26 April 2022
Endeavour Energy Ref: ARP4983

ARP4983 – LOT DP Asset Relocation Application: Package 3 Elizabeth Street, CECIL PARK

Design Brief

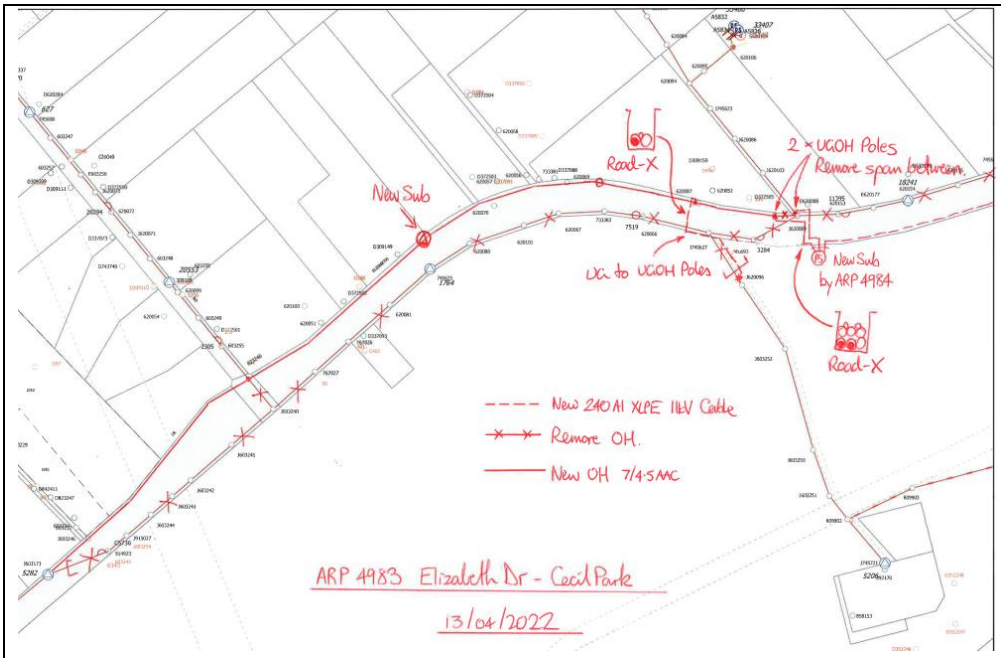
Method Of Supply Requirement:
Method of Supply
The following asset relocation works are for this development:
Substation & Switching Station Works
• Remove Pole Sub at ref ‘29’ at Elizabeth Dr.
• Install New Pole Sub at ref ‘9’ at Elizabeth Dr.
HV Works
• Remove OH HV cable between pole at ref ‘1’ and pole at ref ‘20’ along southern side Elizabeth Dr as shown on sketch.
• String new OH HV cable between pole at ref ‘1’ and pole at ref ‘20’ along northern side
Elizabeth Dr as shown on sketch.
LV Works
• Remove OH LV cable between pole at ref ‘23’ and pole at ref ‘20’ along southern side
Elizabeth Dr as shown on sketch.
• String new OH HV cable between pole at ref ‘3’ and pole at ref ‘20’ along northern side
Elizabeth Dr as shown on sketch.

SL Works
• Remove SL and install new SL as shown on the sketch.
General
• Pole location, pole number, and pole loading calculation to be carried out during detail
design.
• New OH road crossing service connection proposed to maintain existing service connection
Duct Works
• Lay new as per EE standard.

Design Brief:
Design’s MOS is generally acceptable except for changes as shown on mark ups below.
